SR13-93

DATE :	JANUARY 2014	SECTION :	18 - Body
SUBJECT:	IMMI Seat Belt may be difficult to unlatch

Image: IMMI

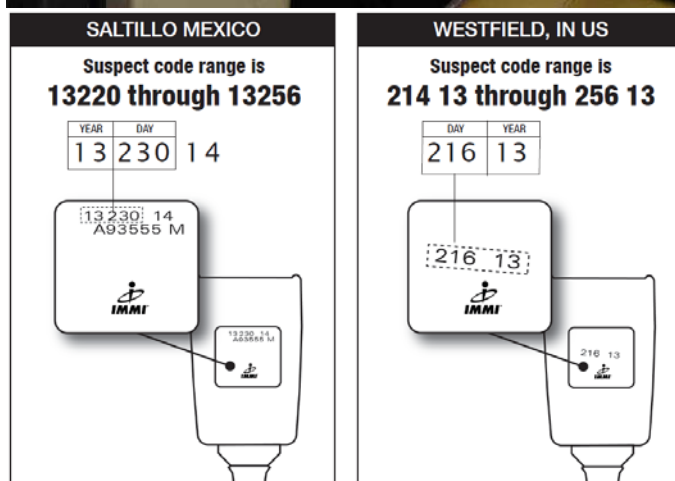
Locate the side-wall mounted retractable shoulder belts in the vehicle.
Check the date code on the other side of the buckle.

Two suspect date code ranges are involved:

13220 through 13256

214 13 through 256 13.

If the buckle date code is within either of the ranges above, replace the part.

Select the retractable shoulder belt in assembly #864813.

Install on wall.

Torque belt anchor to 27 lbf-ft
